Access Compliance Report

Public Rights-of-Way

(Curb Ramps)

Intersection ID: 2711	Main Street: FAIRWAY_POINT_DR	Cross Street: RAVENCREST_DR	Location: NE
ADA ID: 8D456350BFE6	Ramp Type: BlendTrans1	Initial Pass/Fail: Fail	Overall Compliance: No
Severity Score: 33.75			
Codes/Mitigation Info/Possible Solution		Field Measurements/Component Compliance

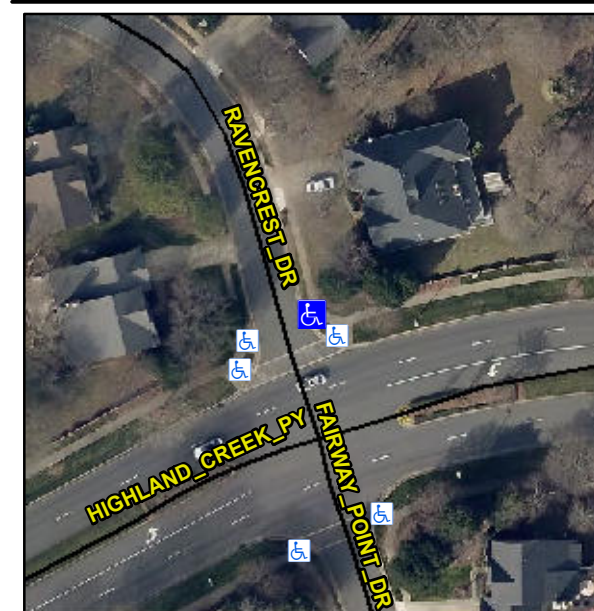
Not Found, R304.5.1, R304.5.3

Compliance	Description	Data	Compliance	Description	Data
N/A	Ramp Length (in)	59.0	Yes	BlendTrans Slope (%)	2.1
No	Ramp Width (in)	36.0	No	BlendTrans XSlope (%)	12.1
N/A	Flare Type LT	N/A	N/A	Flare Type RT	N/A
N/A	Flare Slope LT (%)	N/A	N/A	Flare Slope RT (%)	N/A
N/A	Flare Traversable LT?	N/A	N/A	Flare Traversable RT?	N/A
N/A	Landing Length (in)	N/A	N/A	DWS Provided?	N/A
N/A	Landing Width (in)	N/A	N/A	DWS Contrast?	N/A
N/A	Landing Slope (%)	N/A	N/A	DWS Length (in)	N/A
N/A	Landing X Slope (%)	N/A	N/A	DWS Full Width?	N/A
N/A	Landing Curb? (Y/N)	N/A	N/A	DWS Offset (in)	N/A
N/A	Shared Landing?	N/A			
N/A	Gutter Ponding?	N/A	N/A	Gutter Slope (%)	N/A
N/A	Gutter Lip Ht (in)	N/A	N/A	Gutter X Slope (%)	N/A
N/A	Painted X Walk1?	No	N/A	Painted X Walk2?	N/A
	X Walk 1 Direction	To W		X Walk 2 Direction	N/A
	X Walk 1 Width (in)	N/A		X Walk 2 Width (in)	N/A
	X Walk 1 Slope (%)	3.7		X Walk 2 Slope (%)	N/A
	X Walk 1 X Slope (%)	8.8		X Walk 2 X Slope (%)	N/A

N/A	Ramp inside XWalk1?	N/A	N/A	Ramp inside XWalk2?	N/A
	Road Slope (%)	8.8		Clear Space?	N/A
	Road X Slope (%)	3.7	N/A	Clear Space to XWalk (in)	N/A
N/A	Any Obstructions?	N/A	N/A	Storm Grate/Utility Hazard?	N/A
	Obstruction Type			Storm Grate/Utility Type	
		N/A			N/A
			Yes	Surface Condition? (G/P)	Good
			No	Curb Slope (%)	10.7

Remove & Replace Curb Ramp With Two New Directional Ramps or Equivalent.
